Harbour Rehab  
Pan Am Pier, Wharf 405 Gimli, MB  
F2470-180003

Addendum No. 1

**PAN AM PIER AND WHARF 405 REHABILITATION – GIMLI, MB**

**ADDENDUM – SITE  
 CONTROL AND LAYDOWN  
 DETAILS**

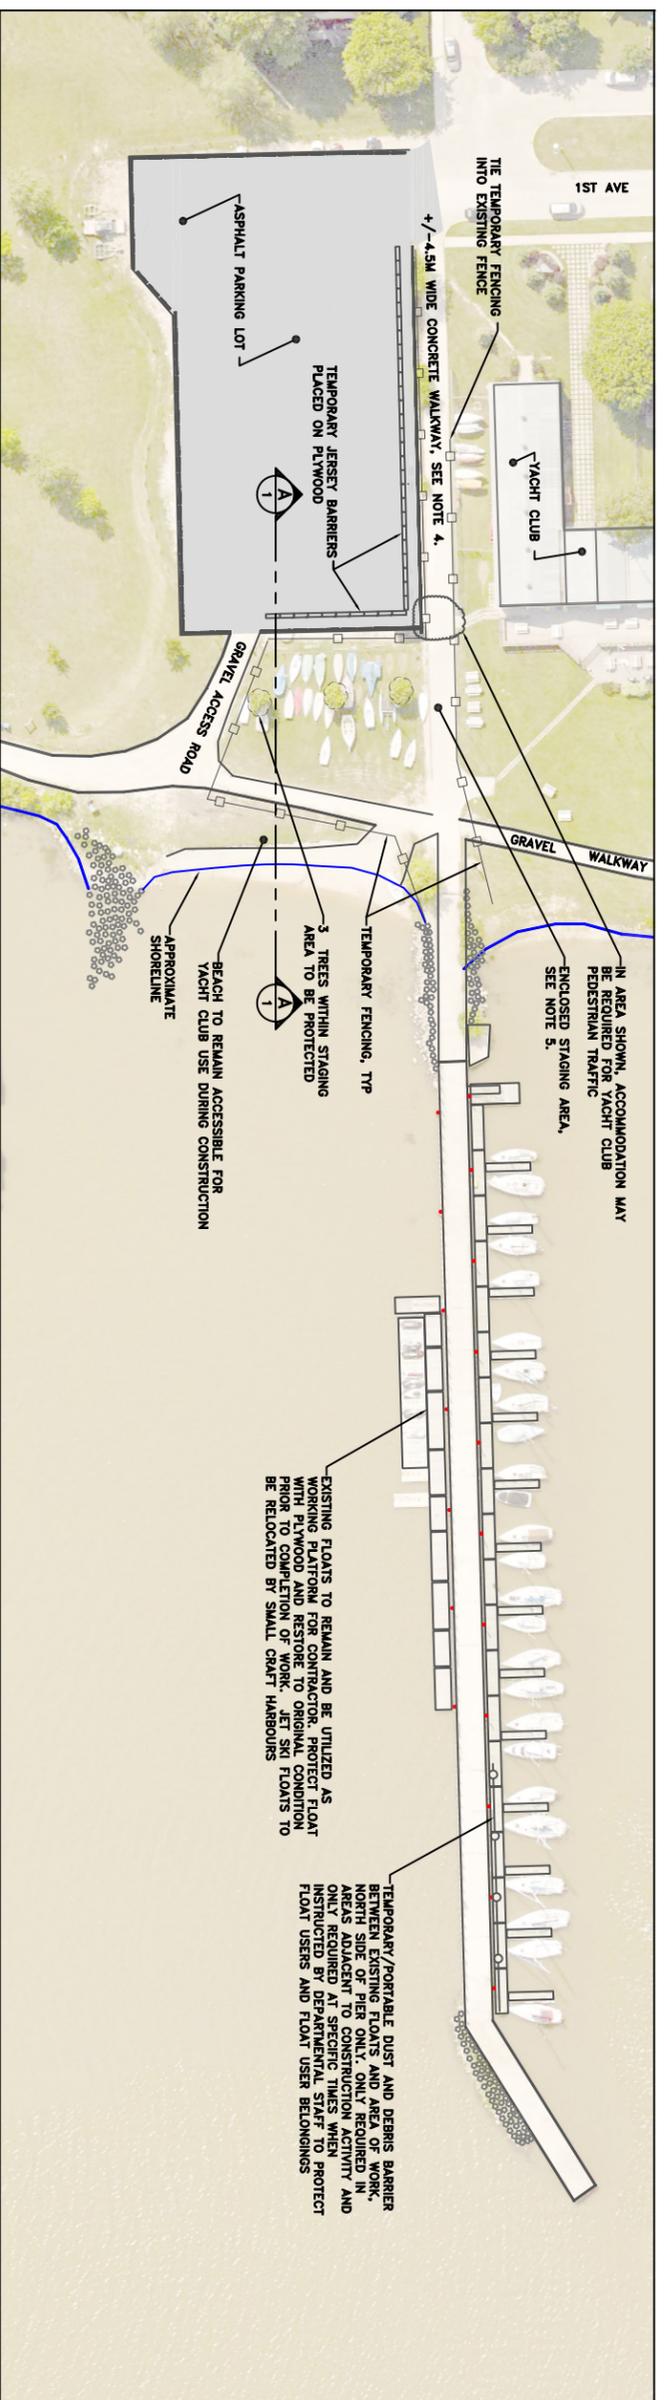
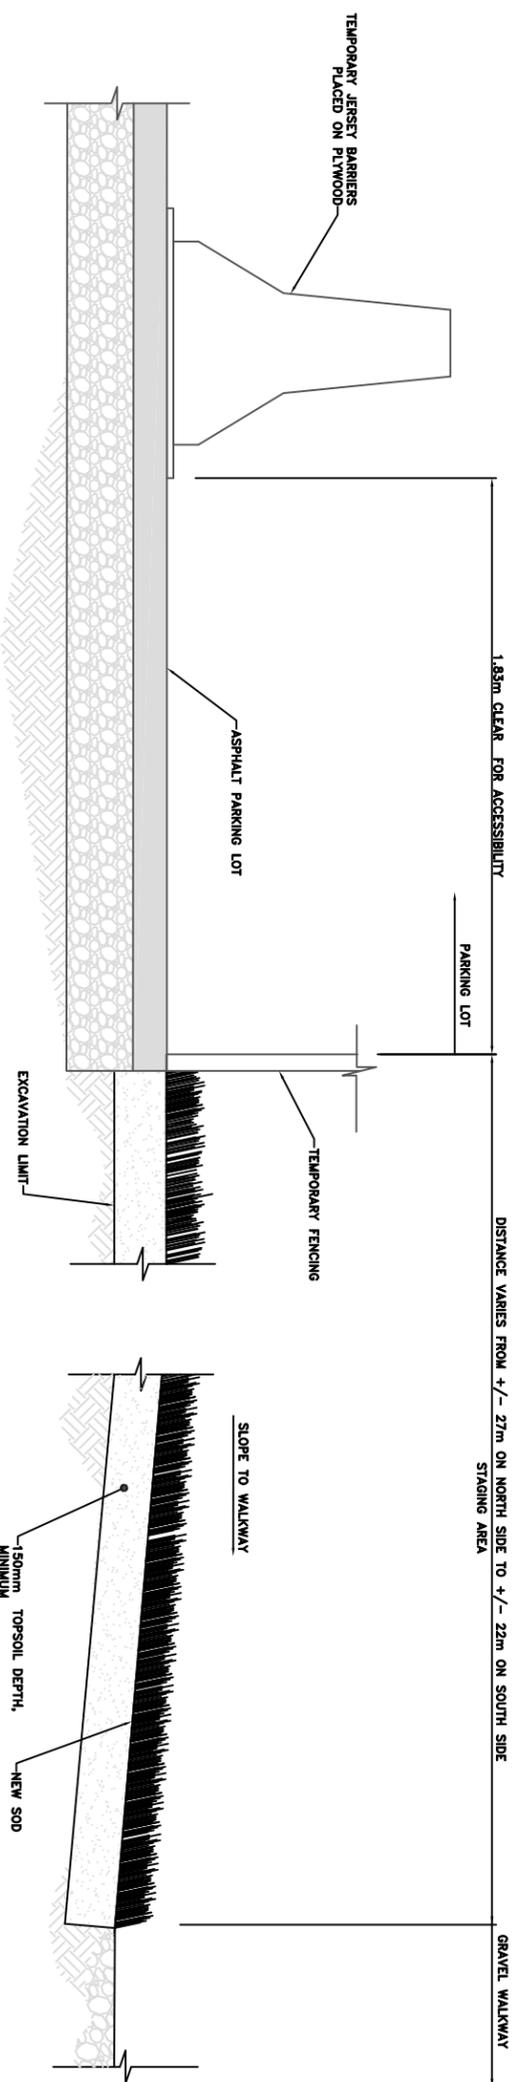
- Discussion to follow regarding floats on south side –
      - Note – see plan of Site Control and Laydown Details attached to Addendum

- Contractor responsible for pedestrian control for work on Wharf 405
8. Lay Down Area – Review site control and laydown details included in this addendum. Note staging area is not 100m from shore and cannot be used for temporary fuel storage.

1. Is there a walking trail along the water edge, if so what steps need to be taken for safety?
  - See plan of Site Control and Laydown Area for details

- Boats will remain on the north side of the pier, and removed from the south side of the pier per the Site Control and Laydown Area Plan
3. When concrete is being poured with a concrete pump truck the boats will have to be removed by at least 30 meters. How would this be accomplished?

- See plan of Site Control and Laydown Area for details
6. Since some dust can not be avoided during construction, are we expected to wash down each sailboat on a daily basis if present and dusty? And who evaluates the level of dust acceptable?
